# TSGRP#12(01) 0398

Title: Agreed CRs to TS 25.435

### Tdoc R3-011427

CHANGE REQUEST									
*	25.435 CR 042								
For <u><b>HELP</b></u> on u	using this form, see bottom of this page or look at the pop-up text over the \ symbols.								
Proposed change affects:    (U)SIM									
Title:	Identify some parameter only used in 3.84Mcps TDD								
Source: #	CWTS								
Work item code: ₩	LCRTDD-lublur Date: # May 2001								
Category:	F Release: # REL-4								
	Use one of the following categories:  F (essential correction)  A (corresponds to a correction in an earlier release)  B (Addition of feature),  C (Functional modification of feature)  D (Editorial modification)  Detailed explanations of the above categories can be found in 3GPP TR 21.900.  Use one of the following releases:  2 (GSM Phase 2)  R96 (Release 1996)  R97 (Release 1997)  R98 (Release 1999)  REL-4 (Release 4)  REL-5 (Release 5)								
Reason for change	e: X Some IEs only used in 3.84Mcps TDD,not in 1.28Mcps TDD.

Figure 30: Structure of the Timing Advance control frame

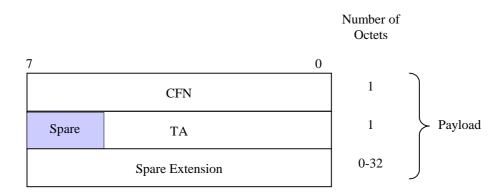
Summary of chang	<ol> <li>In section 6.2.7.13, the title '[TDD — Rx Timing Deviation on RACH]' is changed to '[3.84Mcps TDD — Rx Timing Deviation on RACH]'.</li> <li>In section 6.3.3.8, the title '[TDD - Timing Advance]' is changed to '[3.84 Mcps TDD Timing Advance]'.</li> </ol>								
Consequences if not approved:	# The discription of some IEs is not accurate.  Backward compatibility: These descriptive additions are backward compatible with the previous version of the TS.								
Clauses affected:	<b>%</b> 6.2.7.13, 6.3.3.8								
Other specs affected:	# Other core specifications # Test specifications O&M Specifications								
Other comments:	*

### 6.3.3.8 [3.84 Mcps TDD - Timing Advance]
